NOTICE OF VIOLATION

Georgia Power Company
Hatch Nuclear Plant

Docket Nos. 50-321 and 50-366
License Nos. DPR-57 and NPF-7
EA 95-167

LPCI INJECTION VALVE ISSUES

Cracked Shaft (2E11-F015B)

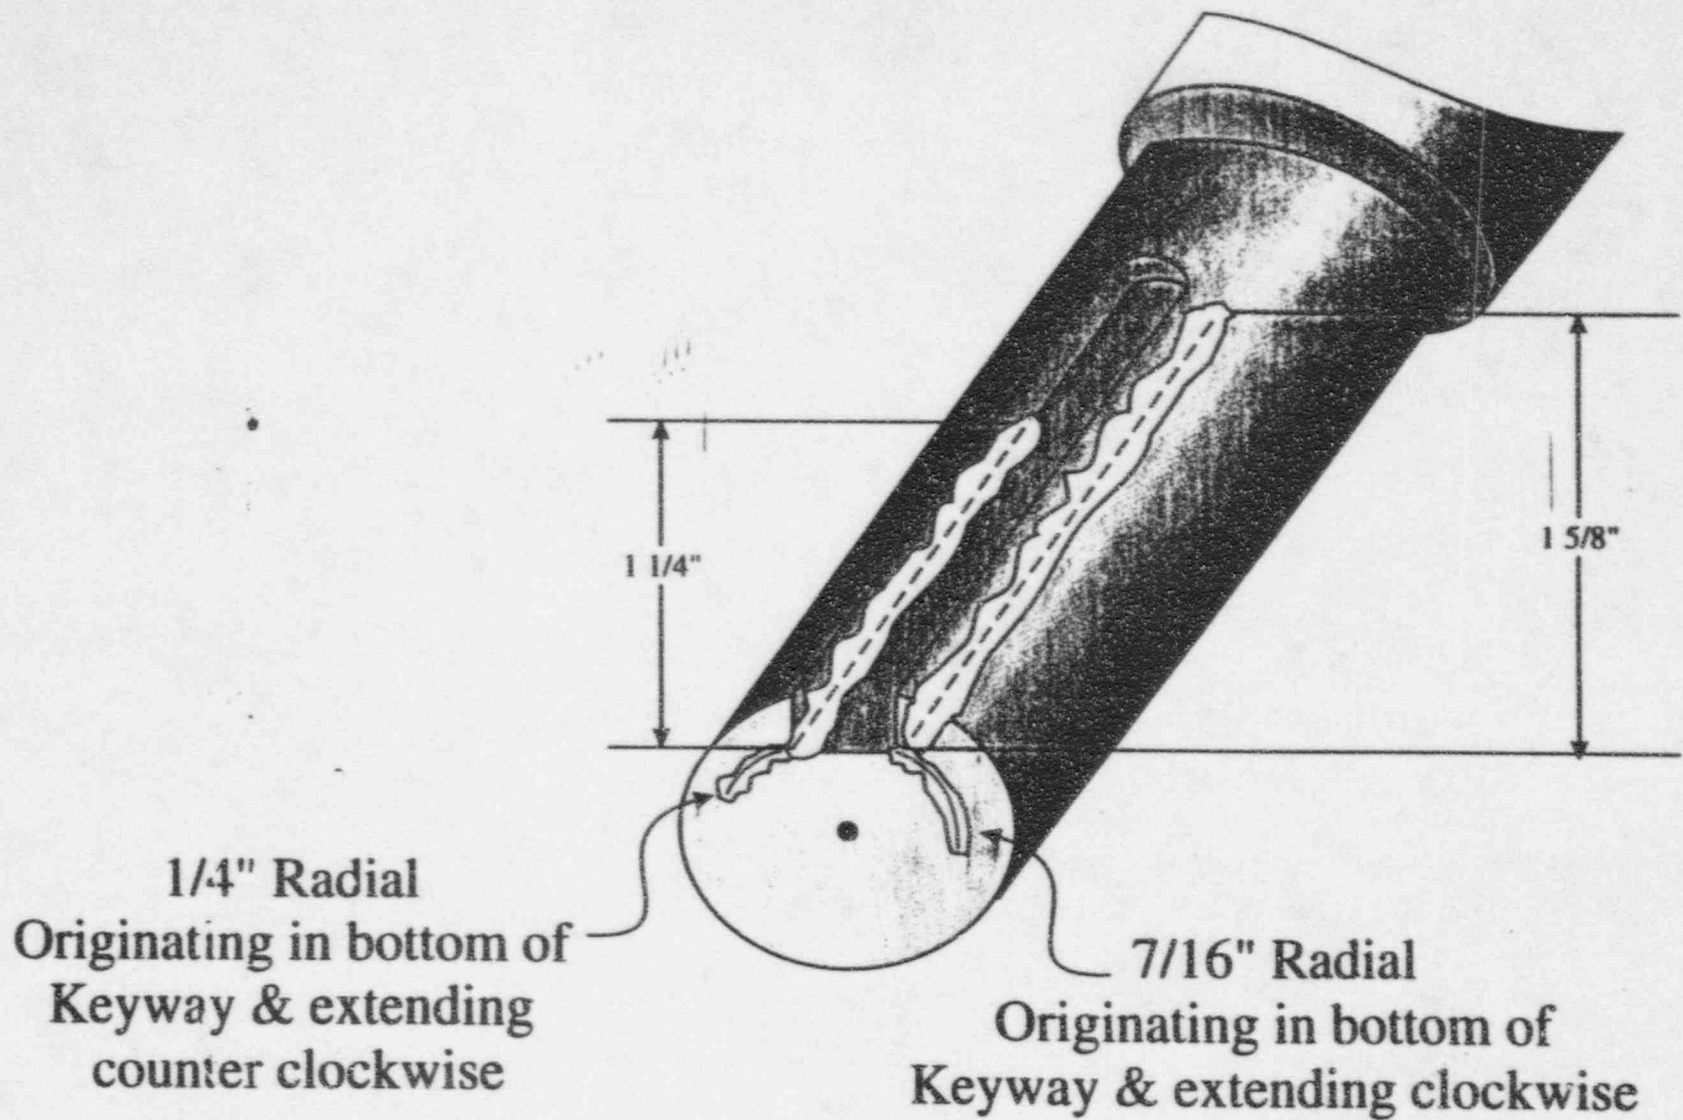
<u>VALVE</u>	<u>INSPECTION/ANALYSIS RESULTS</u>
1E11-F015A	Motor pinion key was sheared. No cracks in shaft. Key was made of 1018 steel.
1E11-F015B	Motor shaft was broken at the keyway. Shaft had cracks emanating from <u>both edges</u> of the keyway as a result of fatigue. Final failure was result of torsional overload. Shaft material was 1144 carbon steel. Key material was 4140.
2E11-F015A	Shaft was cracked. Key was half way out of keyway, had a small crack, and was 4140.
2E11-F015B	Shaft from motor which failed on 5/19/95 was cracked. Had been in service ~9 years with a 4140 key, 1144 shaft .

Root Cause Analysis Results:

Shaft cracking and failure are probably result of multiple factors:

- Key & shaft material
- Hammer blow effect
- High motor rpm
- High thrust due to d/p and speed
- Time in service
- Non-radiused keyway corners

Long Term Corrective Actions:

- **Inspect other motor shafts for cracking during upcoming refueling outages.**
- **Continue to pursue solutions to motor shaft cracking with industry experts.**
- **If warranted, advise BWROG and others of potential generic nature of shaft cracking issue.**
